ADDENDUM NO. 3

City of Tukwila, Washington S Boeing Access Road over Airport Way Bridge Seismic Retrofit Project

City Project No.: 91310407

DATE OF ADDENDUM ISSUE: March 31, 2020

S6

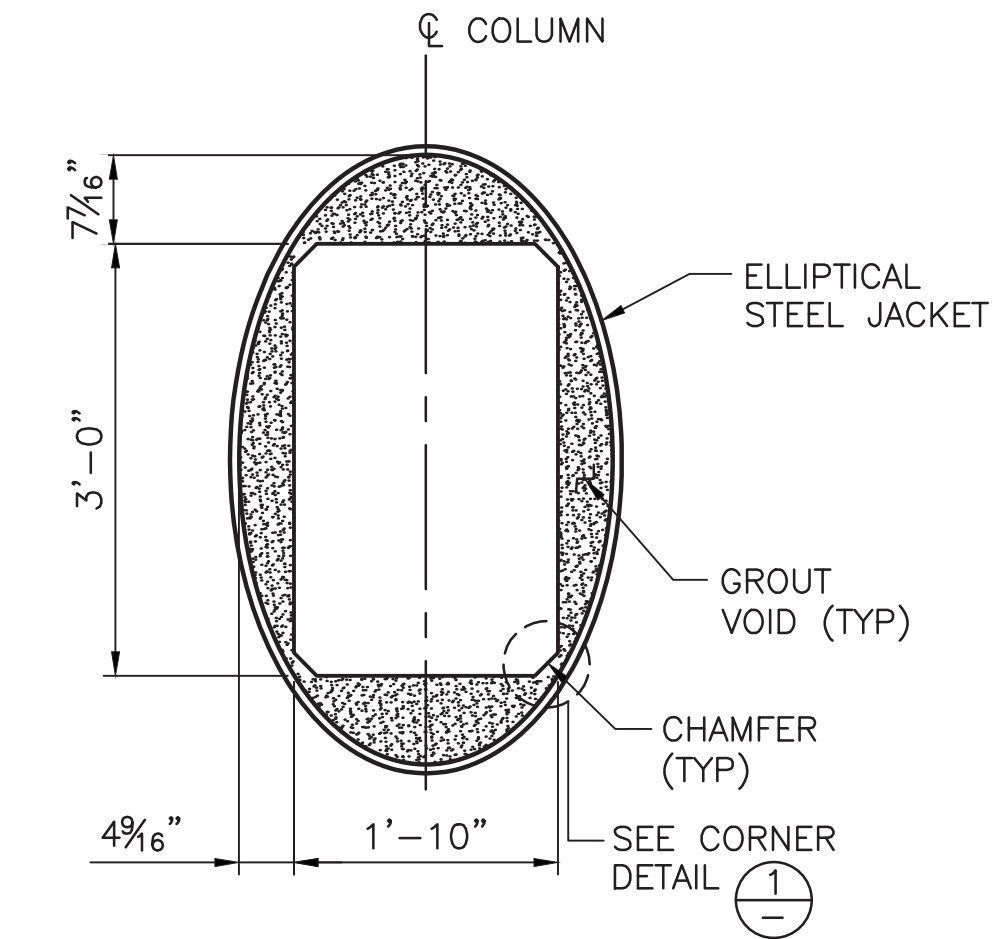
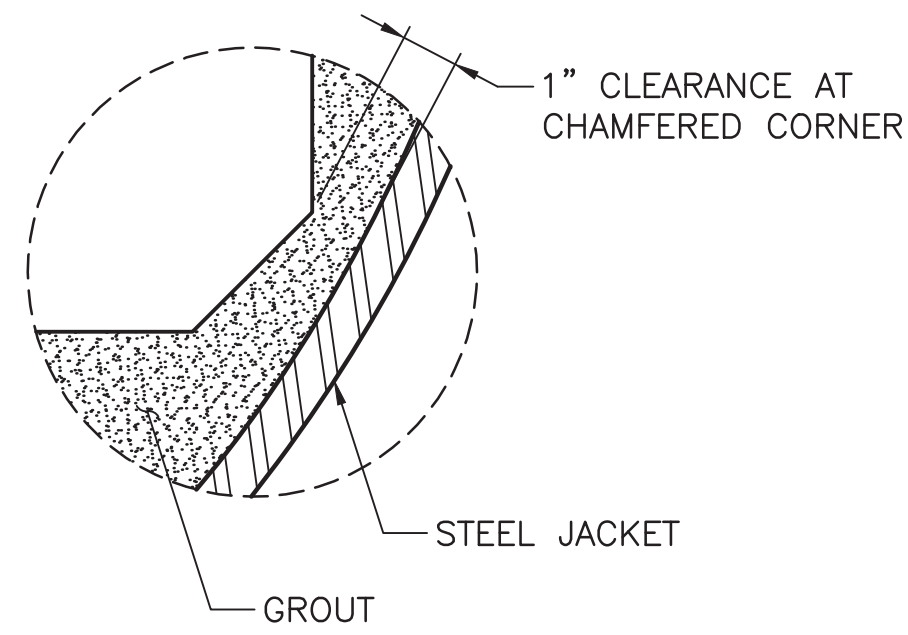
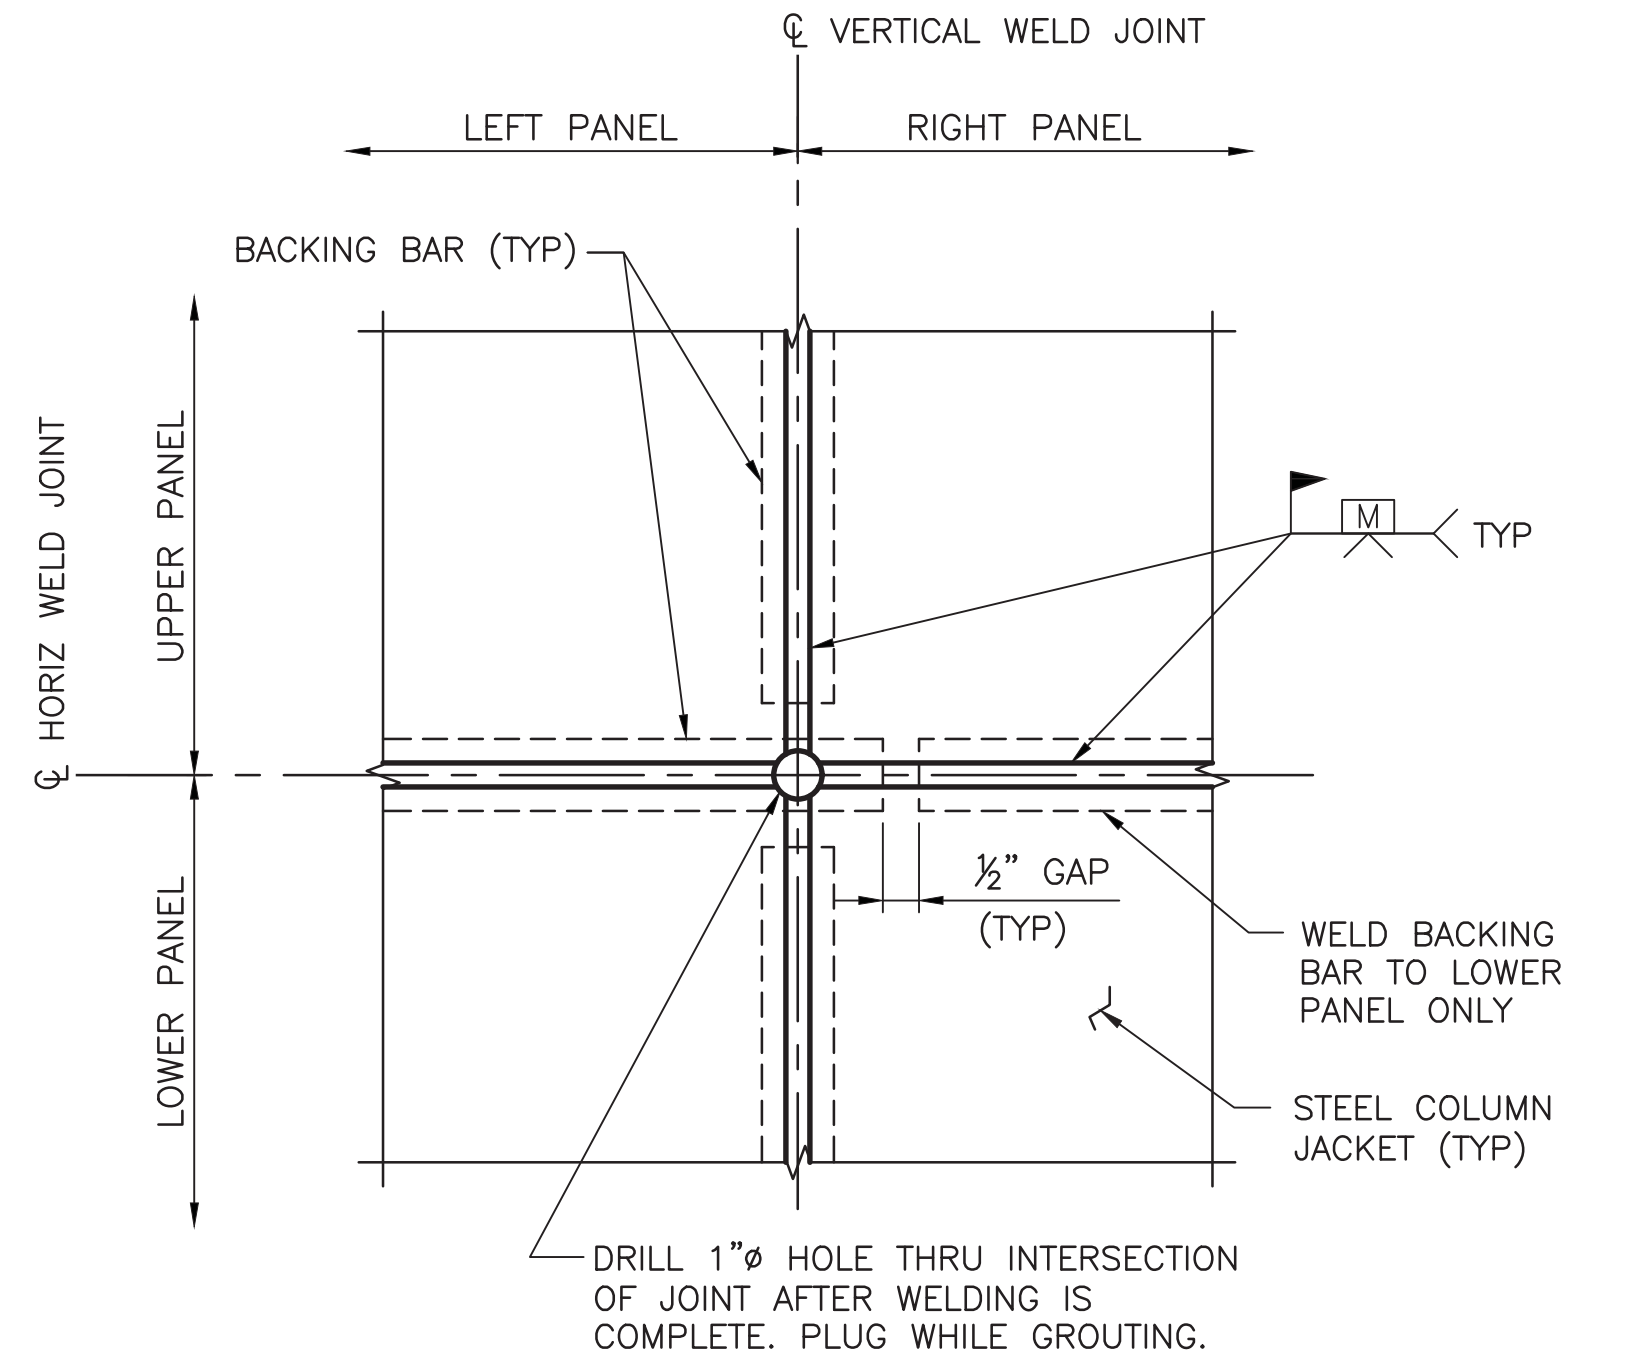
9. Plan Sheet 18 of 23:

DELETE Sheet 18 of 23 and REPLACE with the attached Sheet 18 of 23.

The following changes have been made:

- Note 7 added addressing concrete column repair.

7. COLUMN CONCRETE REPAIR WORK SHALL BE COMPLETED PRIOR TO INSTALLING STEEL COLUMN JACKETS.
